CITY OF ALBUQUERQUE

Re: Liberty Dialysis-Rio Rancho, Conceptual Grading and Drainage Plan. *Chart*
Engineer's Stamp dated (none) (A11D013)

Based upon the information provided in your submittal received September 4, 2012, the above referenced plan is not approved for Site Plan for Building Permit until the following comments have been addressed:

CONCEPTUAL GRADING PLAN

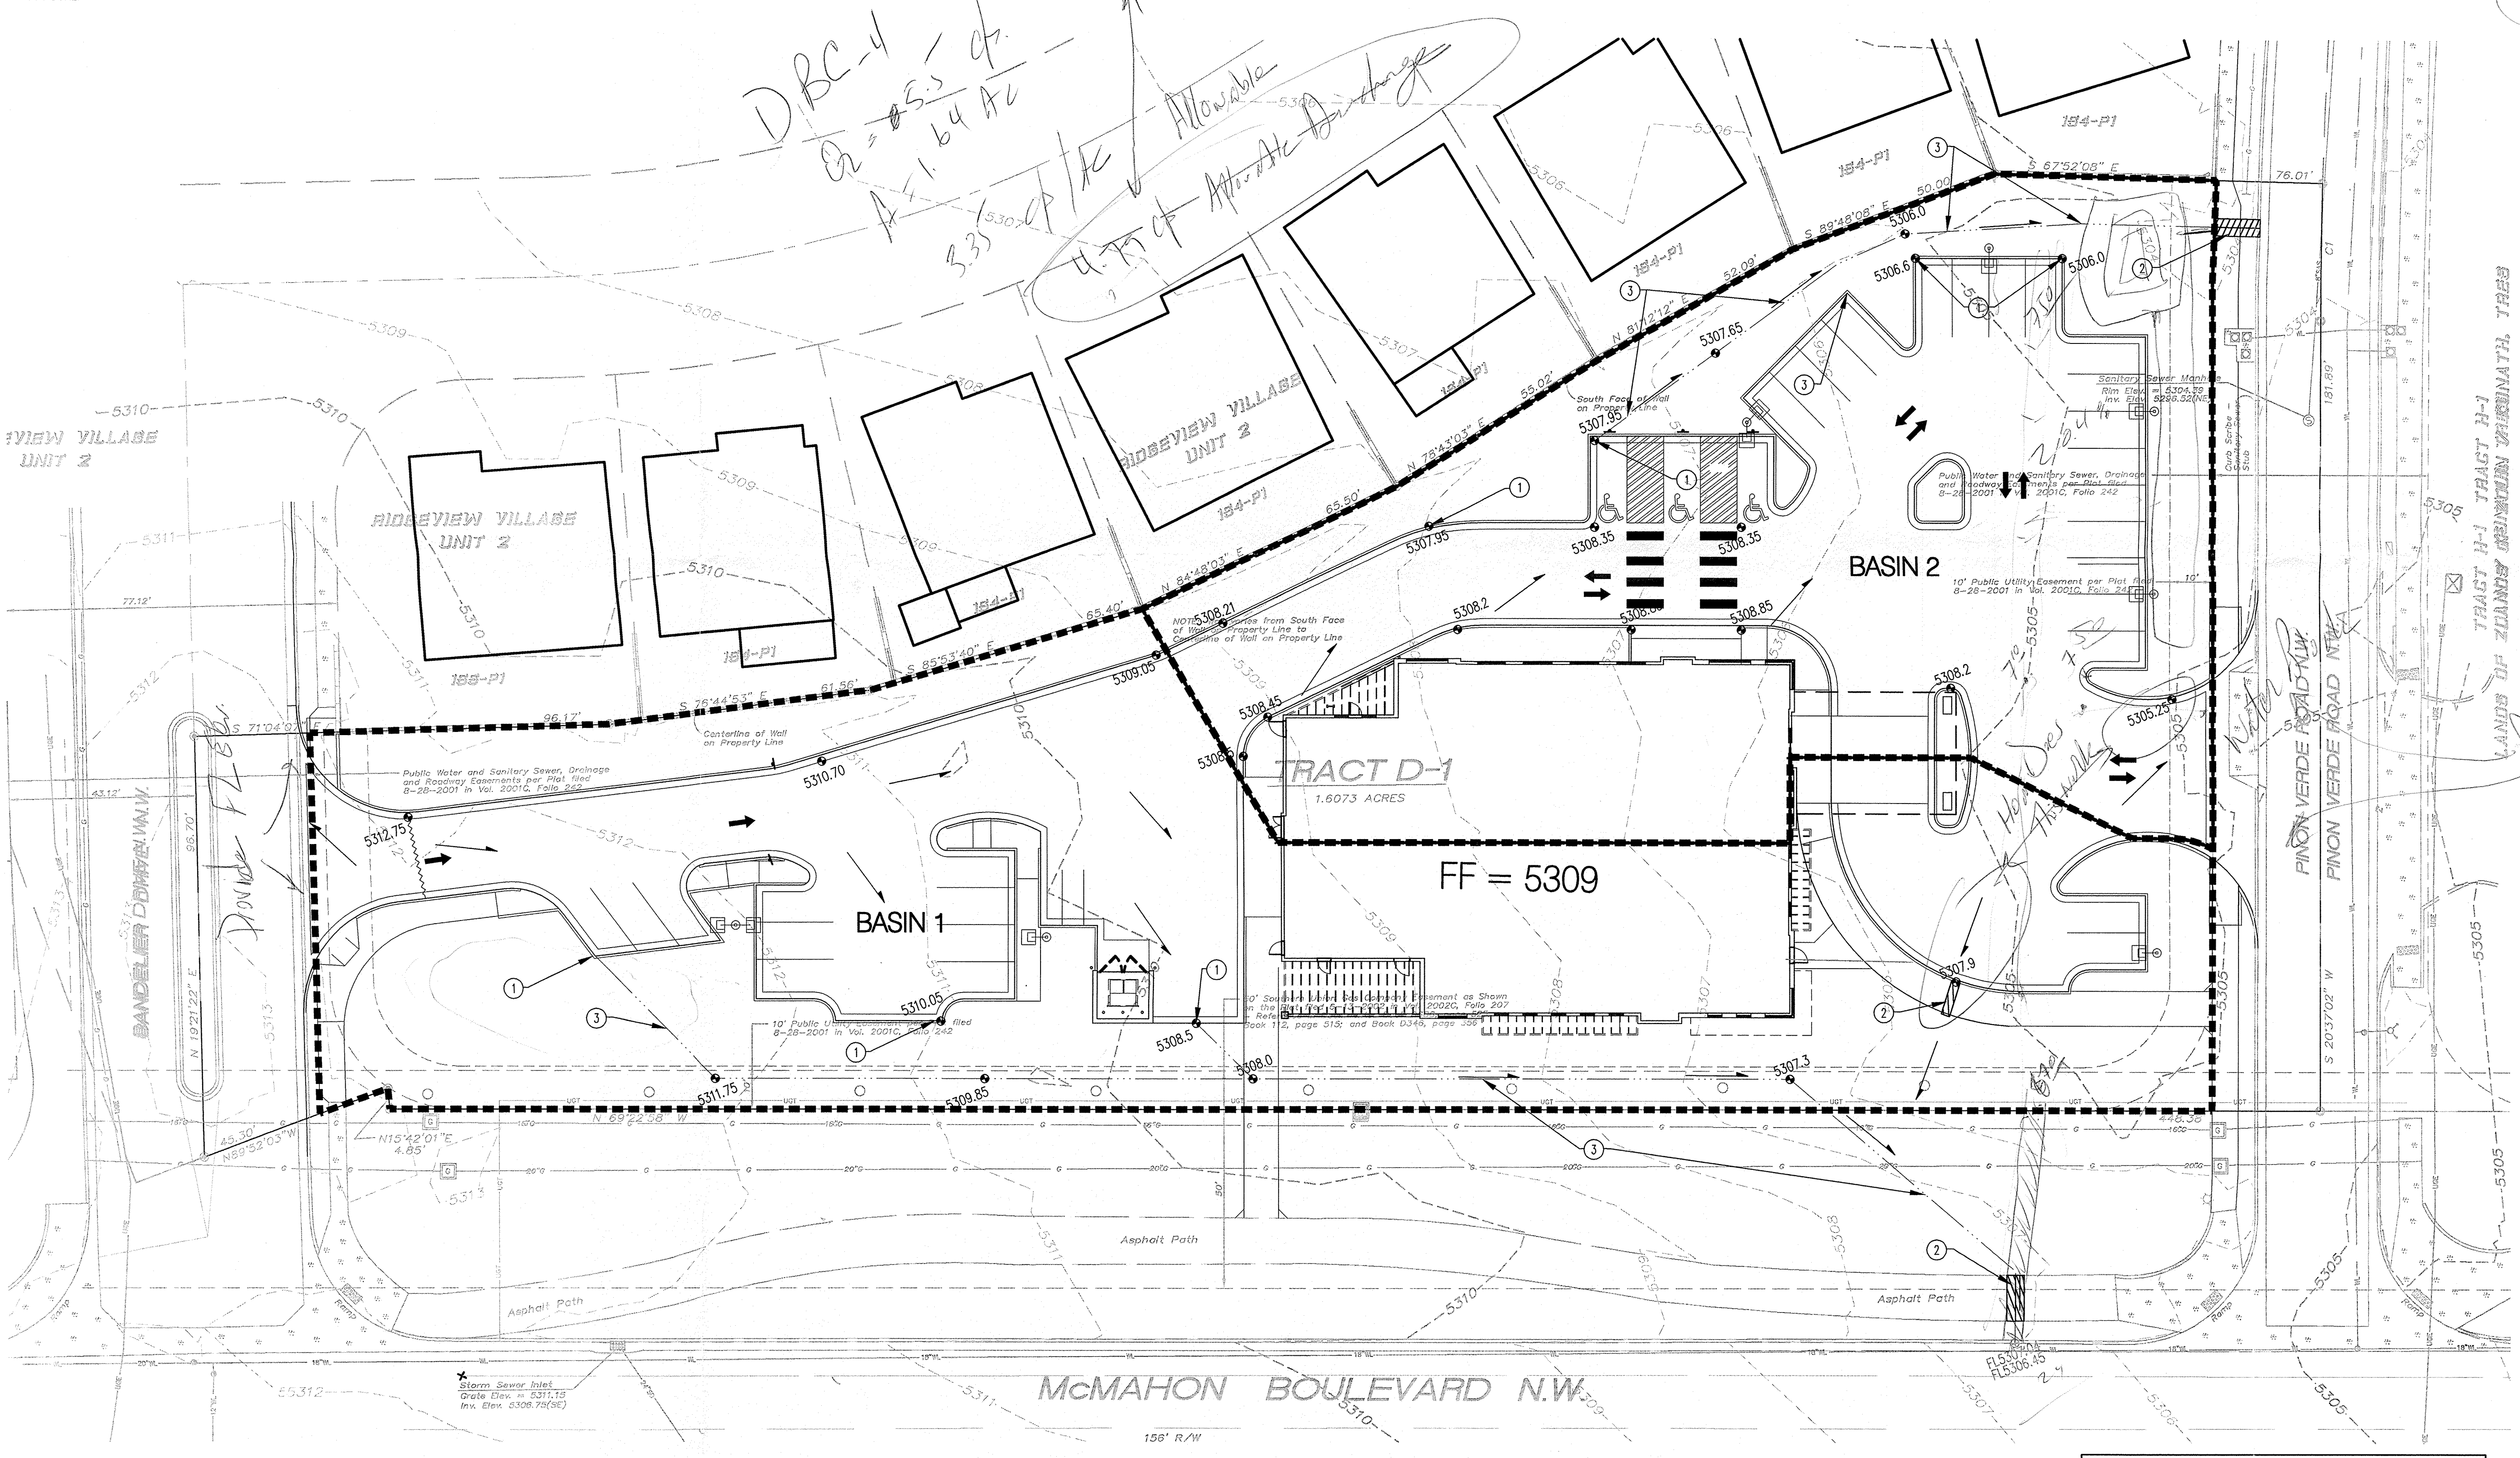
- Based on the Basin DBC-4 from the Master Drainage Plan the allowable discharge is 3.35 cfs/acre (4.79 cfs total).
- It appears that the east end of the project can be raised to drain the runoff to McMahon Boulevard NW as it was intended on the Master Drainage Plan.
- Provide spot elevations along the flow line on Bandelier Drive, Pinon Verde Road, and McMahon Boulevard NW. Clearly mark the high point on Bandelier Drive and Pinon Verde Road.
- Sidewalk culvert must extend from the face of curb to Property Line. Please include a note that Sidewalk Culvert will be built according to the City of Albuquerque Standard Drawing Number 2236 and to tack weld the bolts at the plate.
- Depress all landscaping areas within the property line where possible.
